## SERVICE BULLETIN

ENGINE - LP TURBINE - DELETE THE MARKING REQUIREMENTS FOR THE STAGE 6 TURBINE DISK AND  
LP TURBINE SHAFT - CATEGORY CODE 6 - MOD.ENG-72-0067

V2500-ENG-72-0067

LP turbine shaft and LP turbine stage 6 disk - Position of correlation markings  
Fig.1

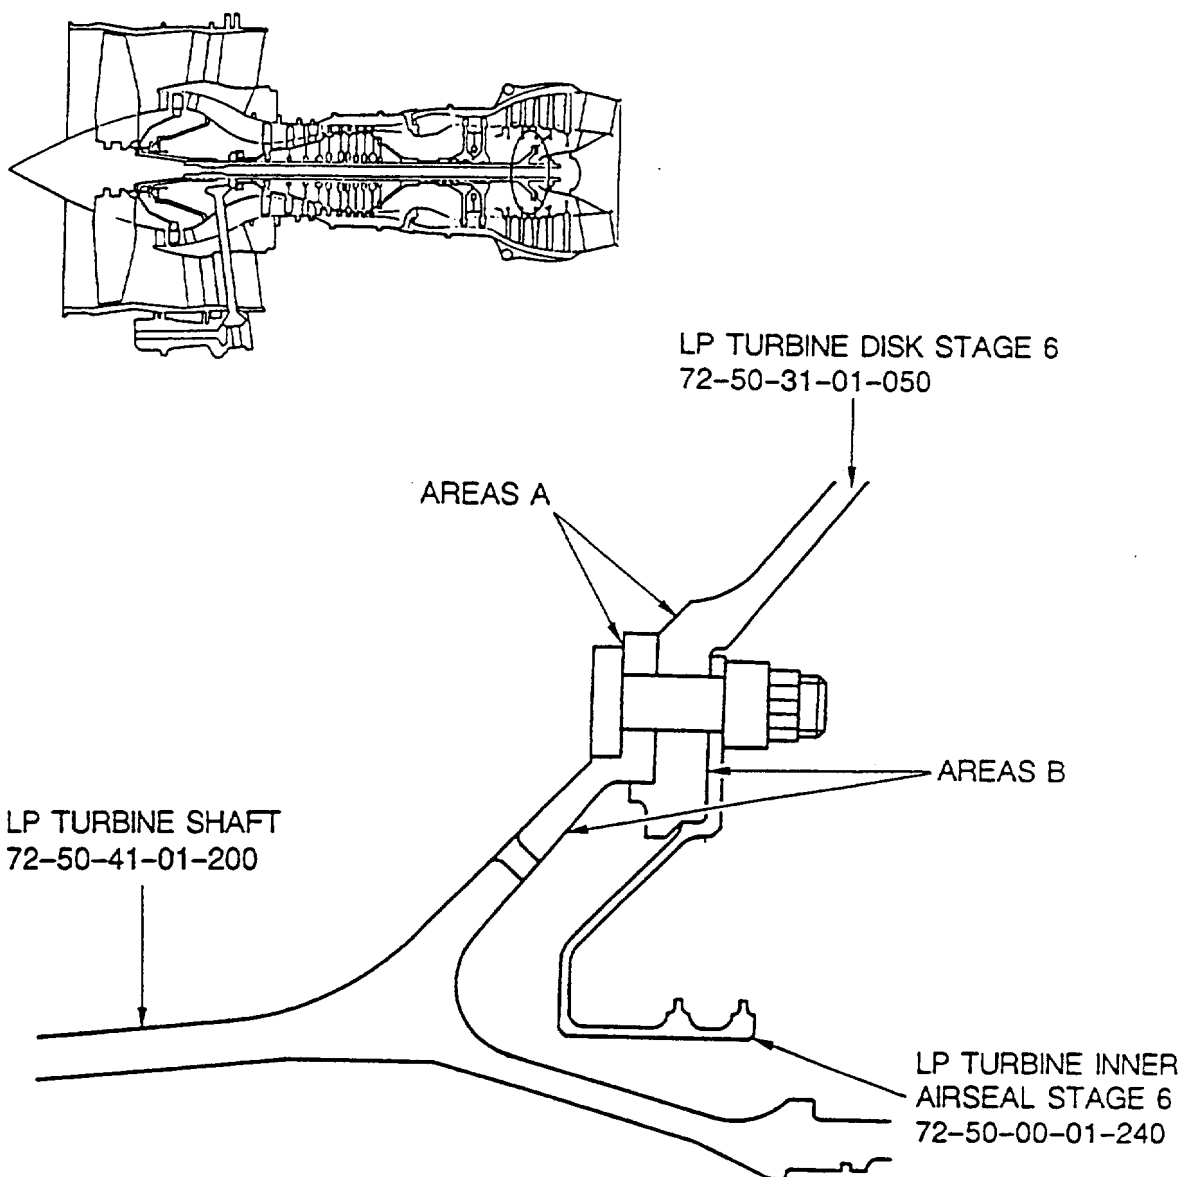
- (1) Identify the correlation marking on the LP Turbine disk stage 6. Refer to Figure 1.

NOTE: The correlation marking may be located on the front or rear side of the LP Turbine shaft connection flange.

- (1) Identify the correlation marking on the LP turbine shaft. Refer to figure 1.

NOTE: The correlation marking may be located on the front or rear side of the stage 6 LP Turbine disk connection flange.

- (3) Remove the correlation marking from the stage 6 LP Turbine disk. Refer to Engine Manual, Chapter 72-50-31, Repair 004 (VRS4157).

(3) Remove the marking from the LP Turbine shaft

- (a) Polish out to remove correlation marking

Use hand held pneumatic grinder and abrasive stones or CoMat 05-020 abrasive paper or CoMat 05-021 abrasive paper.  
The surface finish of the repair must be same as the adjacent area. Polish until all correlation marking is removed.

LP turbine shaft - Corrosion resistance touch-up coating repair  
Fig.2

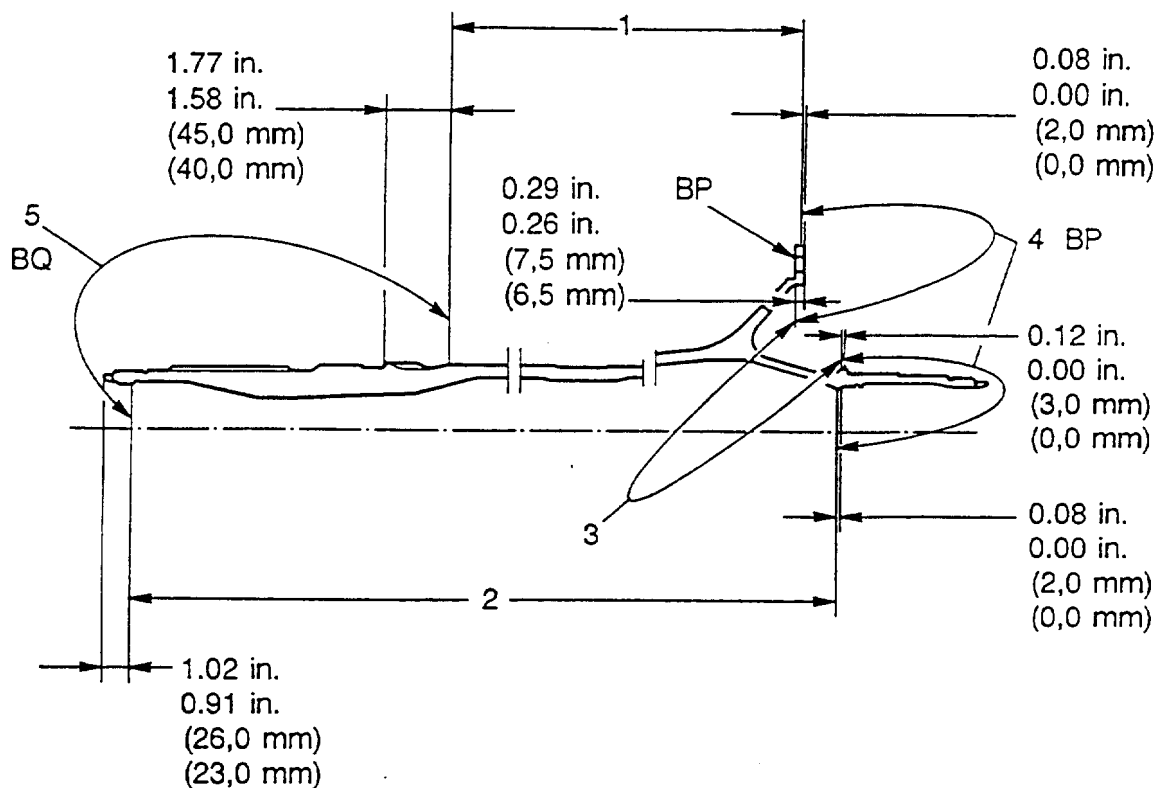
NOTE: 1. Corrosion resistance touch up coating is required after correlation marking removal on rear side of stage 6 disk connection flange. Refer to Figures 1 and 2.

2. Do not coat abutment surface on front side of stage 6 disk connection flange. Refer to Figures 1 and 2.

1. APPLY CORROSION RESISTANCE TOUCH-UP COATING TO THIS AREA
2. APPLY CORROSION RESISTANCE TOUCH-UP COATING TO THIS AREA
3. APPLY CORROSION RESISTANCE TOUCH-UP COATING TO THIS AREA
4. DO NOT COAT ABUTMENT SURFACE OF AREA BP
5. DO NOT COAT ABUTMENT SURFACE OF AREA BQ

| (b) Apply the corrosion resistance coating to the blended area                | Mix thoroughly the CoMat 07-037 corrosion resisting touch-up coating or CoMat 07-038 air drying heat resisting touch-up enamel and apply one coat with a brush. Refer to Figure 2 and TASK 70-38-21-380-501 |
